This representation is made in relation to the planning application at South Hill Farm, Bridgwater Road, Bleadon, BS24 0AL (ref. **13/P/0854/F2**), for the siting of solar photovoltaic (PV) arrays and ancillary development.

Representation

Viewpoint 4 showing the extents of the proposed development site.

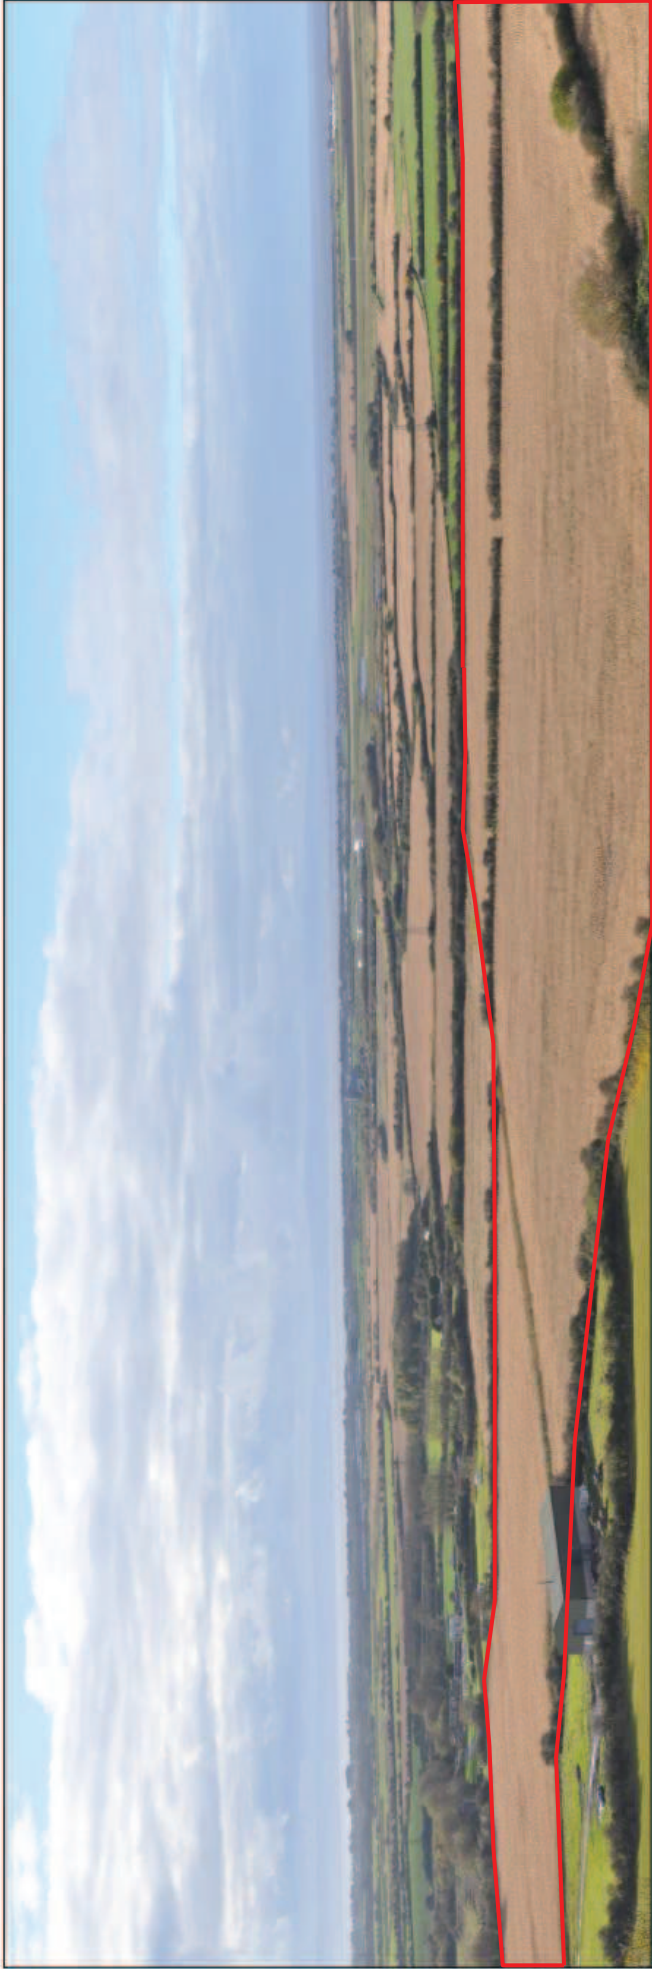
- 1.10. The comparison of the proposed development to other water/wet mud elements in the levels landscape is not considered to be appropriate; rivers, streams, floodplains, the river channel and other naturalistic features would differ significantly from the rectilinear nature of development within the site, and the regular rows of repeating panels. Large scale solar parks appear as extensive and incongruous man-made development features in a landscape setting, particularly from elevated viewpoints such as the area around Viewpoint 4.

- 1.12. There do not appear to be any photomontages actually included within the report (or at least not available online), only the panorama photographs from identified locations. Without photomontages or at least the site boundary identified on the photographs, the descriptions included in the report text do not sufficiently describe the visual presence of the development. For example, the impact on viewpoint 4 would be clearer if the site boundary were superimposed on the photograph, with the extents of the site stretching beyond the wide field of view present in the image. This would more clearly depict the extent to which the proposed development would dominate the view (see below).
